Access Compliance Report

Public Rights-of-Way

(Curb Ramps)

Intersection ID: N/A	Main Street: GLENBURN_LN	Cross Street: GLENLIVET_CT	Location: NW
ADA ID: 03616428BEAF	Ramp Type: PerpDiag	Initial Pass/Fail: Fail	Overall Compliance: No
Severity Score: 22.5			
Codes/Mitigation Info/Possible Solution		Field Measurements/Component Compliance

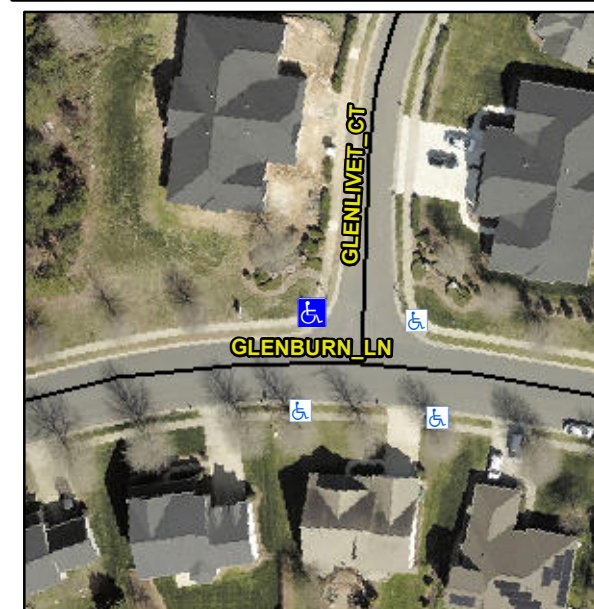
Not Found, R304.5.1, R304.2.2, R304.5.3

Compliance	Description	Data	Compliance	Description	Data
N/A	Ramp Length (in)	46.0	No	Ramp Slope (%)	9.9
No	Ramp Width (in)	41.0	No	Ramp XSlope (%)	3.4
N/A	Flare Type LT	N/A	N/A	Flare Type RT	N/A
N/A	Flare Slope LT (%)	N/A	N/A	Flare Slope RT (%)	N/A
N/A	Flare Traversable LT?	N/A	N/A	Flare Traversable RT?	N/A
N/A	Landing Length (in)	N/A	N/A	DWS Provided?	N/A
N/A	Landing Width (in)	N/A	N/A	DWS Contrast?	N/A
N/A	Landing Slope (%)	N/A	N/A	DWS Length (in)	N/A
N/A	Landing X Slope (%)	N/A	N/A	DWS Full Width?	N/A
N/A	Landing Curb? (Y/N)	N/A	N/A	DWS Offset (in)	N/A
N/A	Shared Landing?	N/A			
N/A	Gutter Ponding?	N/A	N/A	Gutter Slope (%)	N/A
N/A	Gutter Lip Ht (in)	N/A	N/A	Gutter X Slope (%)	N/A
N/A	Painted X Walk1?	No	N/A	Painted X Walk2?	No
	X Walk 1 Direction	To SW		X Walk 2 Direction	To SE
N/A	X Walk 1 Width (in)	N/A	N/A	X Walk 2 Width (in)	N/A
	X Walk 1 Slope (%)	0.2		X Walk 2 Slope (%)	2.4
	X Walk 1 X Slope (%)	2.1		X Walk 2 X Slope (%)	0.6

Remove & Replace Curb Ramp With Two New Directional Ramps or Equivalent.
